PROJECT NUMBER: 1000965
Application Number: QAFPC-008955

ADMINISTRATIVE AMENDMENT

Site Plan for Subdivision

Andaluca at La Luz

Sheet 1 of 3

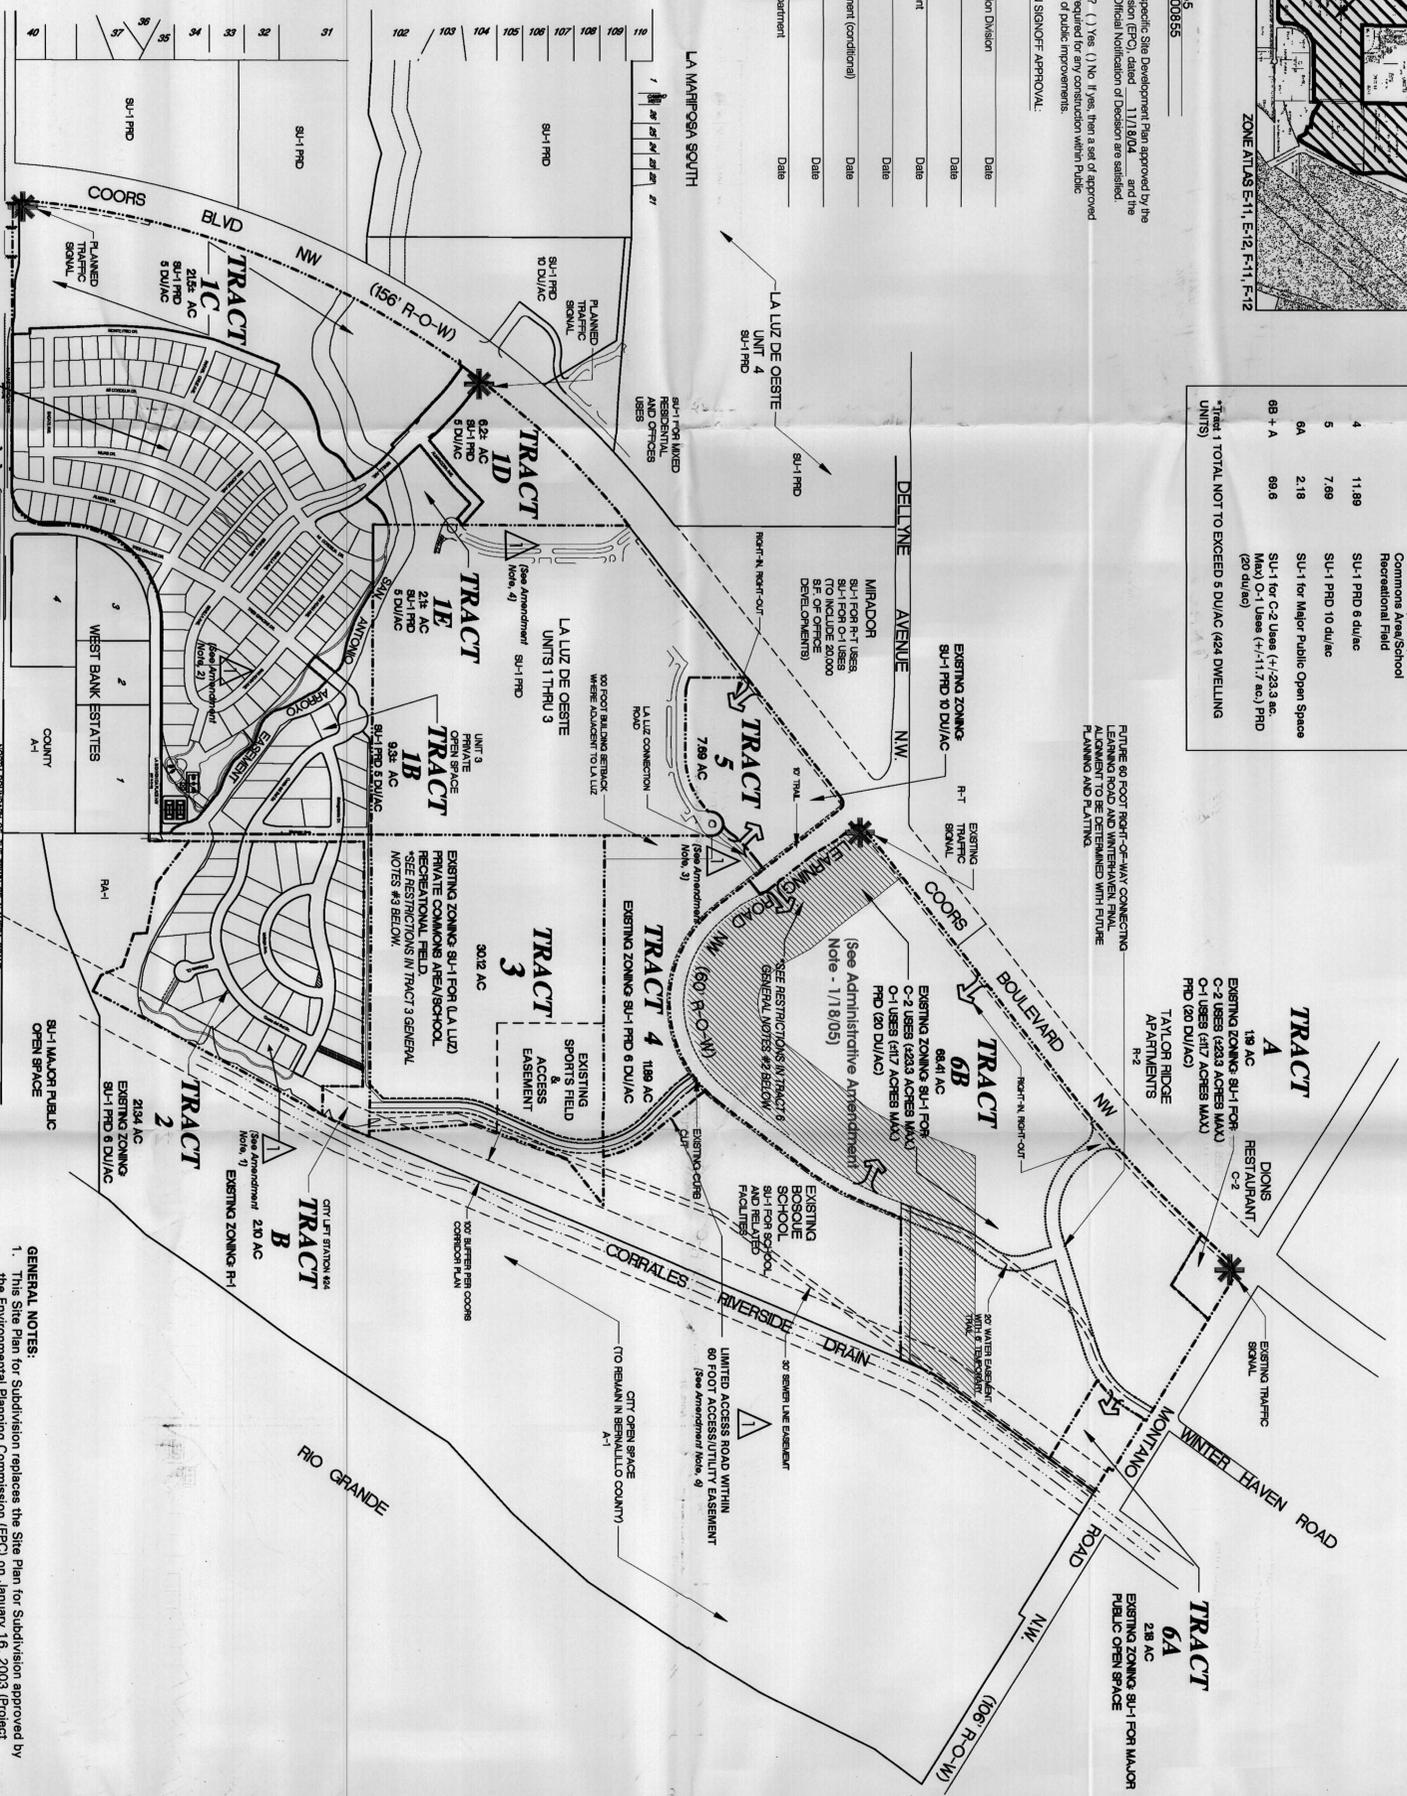
ADMINISTRATIVE AMENDMENT - 1/18/05
Tracts 6B and A have been removed from this Site Plan for Subdivision and a new Site Plan has been created for those two tracts - Project # 1000965, QAFPC 0184.

1. Tract 1B is subdivided into 13 single family lots and Tract 2 is subdivided into 41 single family lots.
2. The Private Recreational Area within Tract 1A has been replaced with 3 single family residential lots.

3. A minor adjustment to the Tract 4 northwestern boundary of the La Luz Connection Road.
4. A minor adjustment to the Tract 1D boundary of the entry road to La Luz subdivision.

5. Clarification that the gross density for Tract 1 shall not exceed 5 du/ac and that individual lots (lots 1A, 1B, 1C, 1D, and 1E) may exceed this density provided the gross density for Tract 1 as a whole is maintained.

6. The 60 foot Access/Utility Easement shall contain a 24 foot limited access road and a 10 foot public trail. The easement is restricted to pedestrian/bicyclist/equestrian, emergency fire access, City Lift Station access for operations and maintenance only, public water and sanitary sewer easement and utilities of all types, and drainage. The road shall be an all-weather gravel surfaced facility, have no lighting, and shall be gated. There shall be no public vehicular access. A pipe rail trail, and fence layout shall be completed prior to final sign-off of the Site Plan by the Development Review Board.

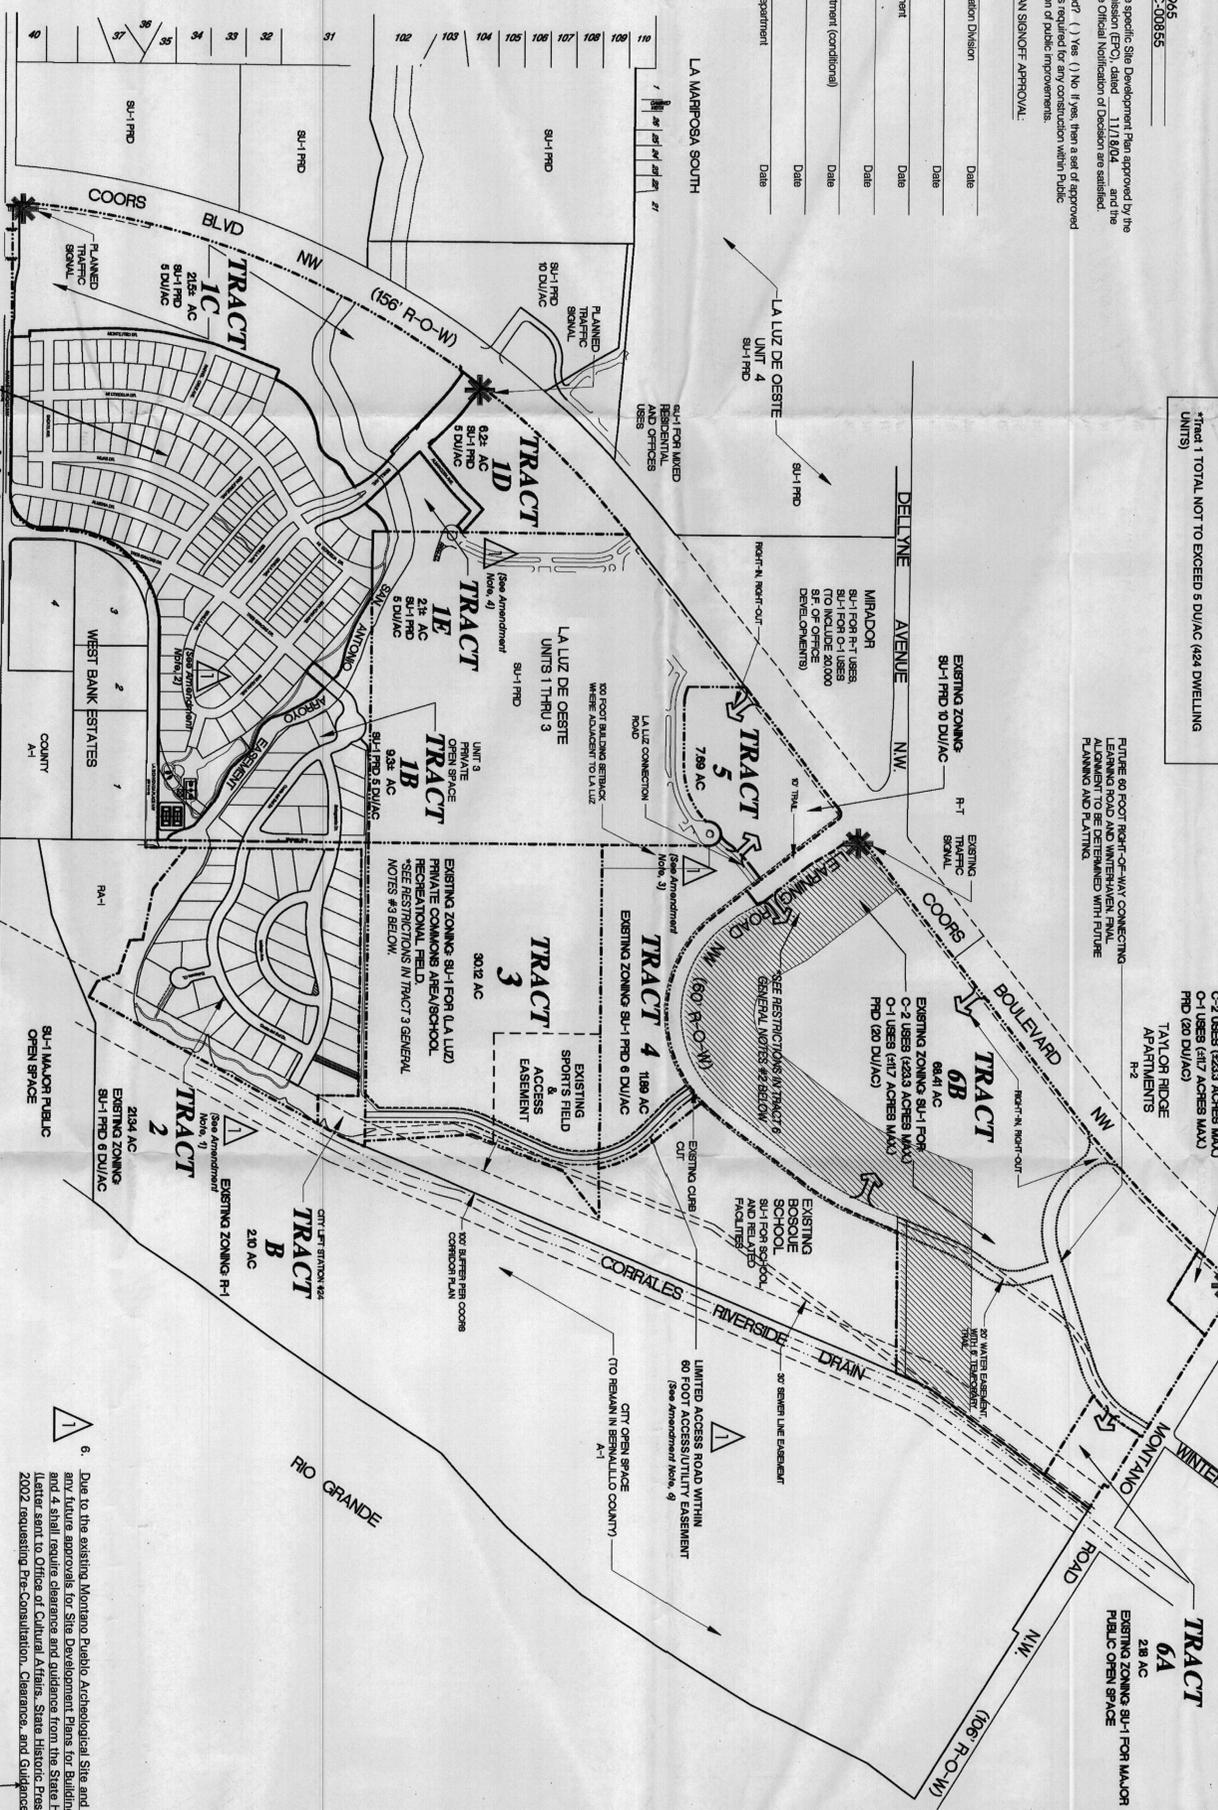
- Amendment Notes**
- Tract 1B is subdivided into 13 single family lots and Tract 2 is subdivided into 41 single family lots.
 - The Private Recreation Area within Tract 1A has been replaced with 3 single family residential lots.

- A minor adjustment to the Tract 4 boundary of the entry road to La Luz Connection Road.
 - A minor adjustment to the Tract 1D boundary of the entry road to La Luz Connection Road.

- Clarification that the gross density for Tract 1 shall not exceed 5 du/ac and that individual tracts (Tracts 1A, 1B, 1C, 1D and 1E) may exceed this density provided the gross density for Tract 1 as a whole is not exceeded.

- The 60 foot easement/Right-of-Way shall contain a 24 foot limited access road and a 10 foot public trail. The easement is restricted to pedestrian/bicyclist/equestrian, emergency fire access, City/Utility access for operations and maintenance only, public water and sanitary sewer, easement and utilities of all types, and drainage. The road shall be an all-weather, gravel surfaced facility, have no lighting, and shall be gated. There shall be no public vehicular access. A paved trail, and fence layout shall be completed prior to final sign-off of the Site Plan by the Development Review Board.
